I. Proposal

Requirement in 6.2.2.3.4.3.

2.5. Grey scale rendering test method

Figure 4: Test arrangement for the grey scale rendering test

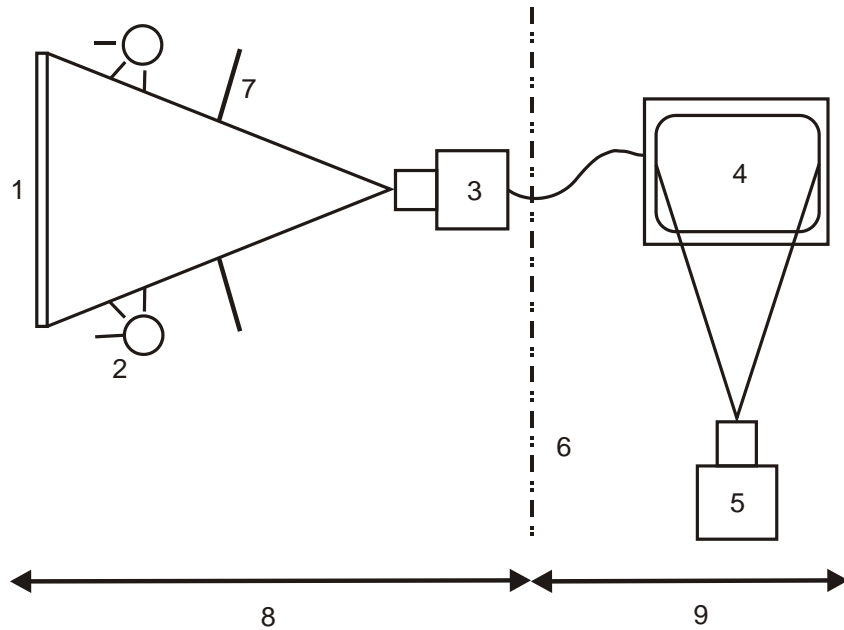
Figure 4 shows the test arrangement for the grey scale rendering test.

- 1: Test chart (grey scale rendering chart)
- 2: Illumination for test chart
- 3: Camera under test
- 4: Monitor under test
- 5: Reference camera
- 6: Optical or spatial isolation between camera and monitor lightning environment
- 7: Optical isolation barrier to avoid direct light into lens
- 8: Camera-side
- 9: Monitor-side

Figure 5: Example of the grey scale rendering chart

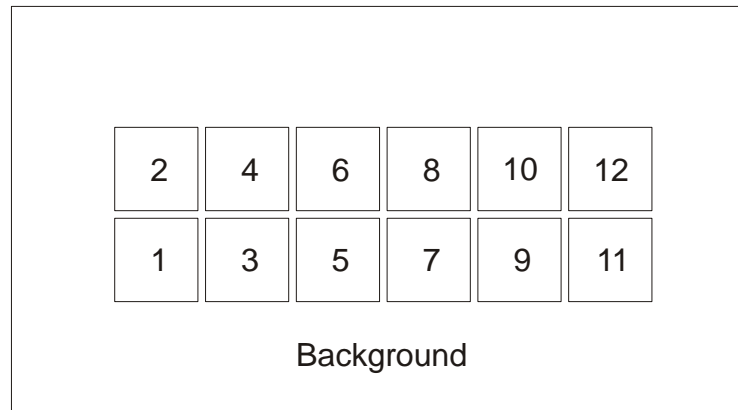
Figure 5 shows an example of a grey scale rendering chart to be used in this measurement. The grey scale rendering chart shall consist of 12 different tonal density grey patches.

The density value D_i may follow the values as defined by ISO 14524:2009 Table A.1 for low contrast 20:1, but it is not restricted to this definition as long as the adopted chart could display a sufficient tonal range of at least 8 distinguishable grey steps on the monitor. The definition of D_i is given in the ISO 14524:2009.

The background of the patches should be covered with a neutral grey colour having a density value D_i of $0.54 \pm 0,05$.

Each patch on the grey scale rendering chart shall have a size of 50 x 50 mm. The distance between the patches shall be 5 mm.
